Our Case Number: ABP-314537-22

Planning Authority Reference Number: SD21B/0618

Re: Two storey, one bedroom family flat to the side; alterations to existing garage elevation; pedestrian access gate to the side garden wall; all associated site works.
279, Orwell Park Grove, Dublin 6w

RESPONSE TO REQUEST FOR
ADDITIONAL INFORMATION
REG. REF. SD21B/0618

DRAWING NO - 22-001 P100
PROPOSED SECTION THROUGH WALL

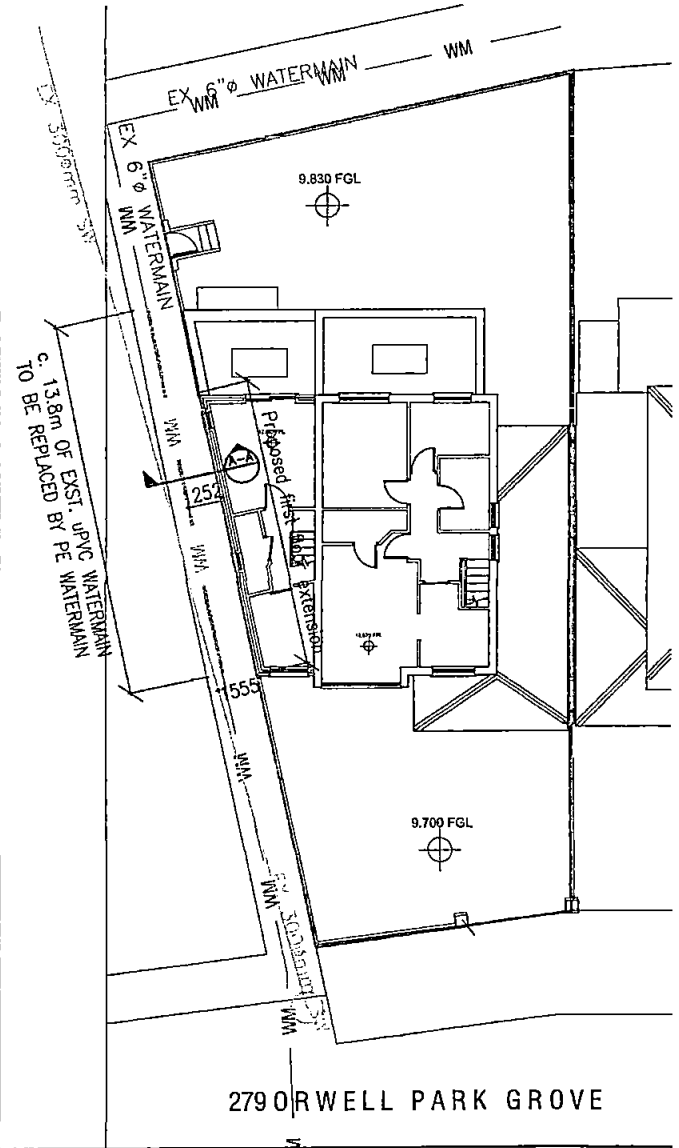
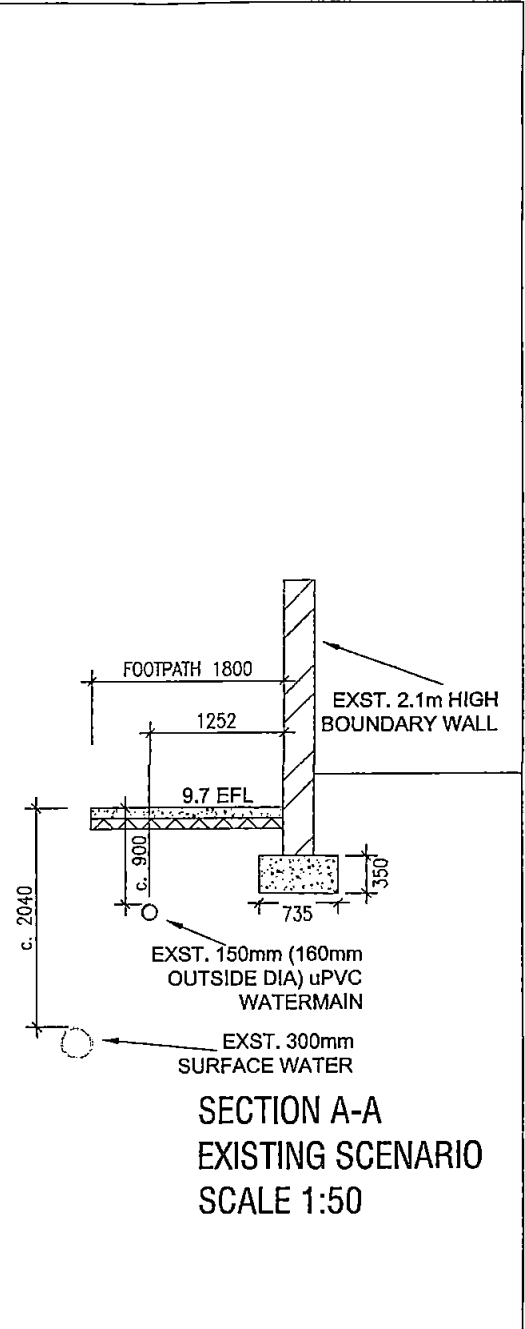
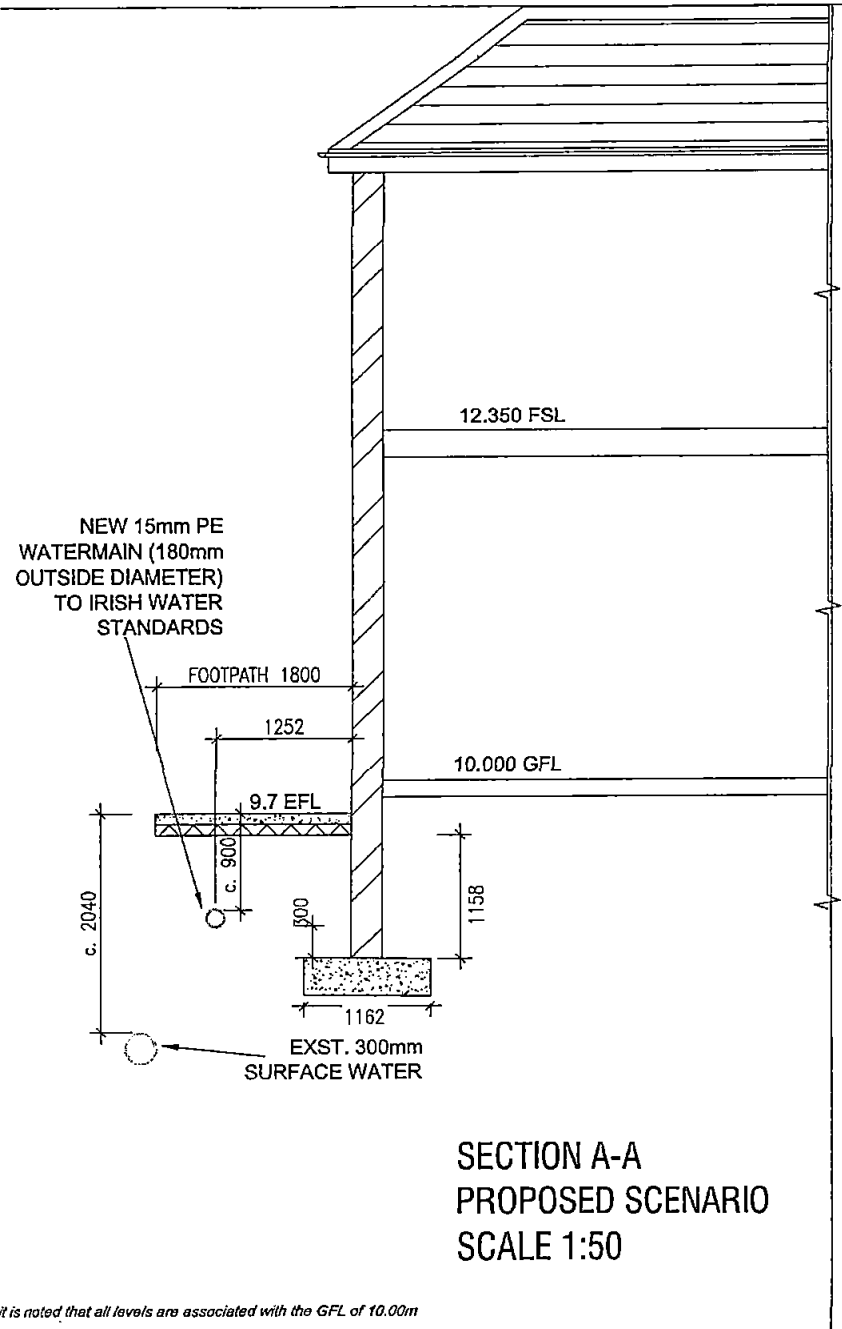
The proposed development is approximately 1.7m from a 6 inch uPVC public watermain located to the east of the site. Irish Water Standard Details for water Infrastructure require 3m clear distance from a main of this size. The applicant is requested to engage with Irish Water's diversions section to assess feasibility of existing design and an alternative design which accommodates Irish Water's minimum required separation distances from public infrastructure. The outcome of this engagement with Irish Water's diversions should be submitted to the planning authority as a response to Request for Further Information.

South Dublin County Council records show that there is an existing 300mm public surface water sewer to the east of the site. The proposed dwelling extension is located too close to this sewer (Closest distance approx.. 1.7m). The applicant is requested to submit a drawing in plan and cross-sectional views showing the distance between the proposed extension and the existing 300mm surface water sewer. The drawings should also show the invert levels of the existing surface water sewer and any adjacent proposed building foundations. A minimum clear setback distance of 3m is required between all proposed structures and the existing surface water sewer.

It is noted that the existing dwelling in its current condition consist of a boundary wall with a height of c. 1.8m which is already deemed as a significant structure. Irish Water's Diversion Section has been contacted in this regard, IW Diversion Reg. Ref. DIV22060. The following works have been conducted as part of this liaising process.

The client's contractor met with the local Irish Water Field Engineer on site and performed a slit trench through said public footpath next to the house. The exact location of the uPVC watermain is located 1.25m from the proposed works area. Irish Water has confirmed that the proposed "Build-Near" can proceed if the section of watermain traversing along the boundary of the property where construction is due to take place is replaced with a PE watermain and the footing of the foundation is deeper than the newly installed watermain.

Please refer to the letter received from Irish Water Diversion Division in Appendix A, as well as a detailed section of the existing vs. proposed works on Drawing P100 in Appendix B.

A detailed section of the boundary section can be seen on Drawing P100 in Appendix B. It is noted that the existing 300mm surface water pipes are generally 2.040m deep all along the boundary and as part of the construction works, all necessary precautions will be in place in order to protect the existing surface water pipe.
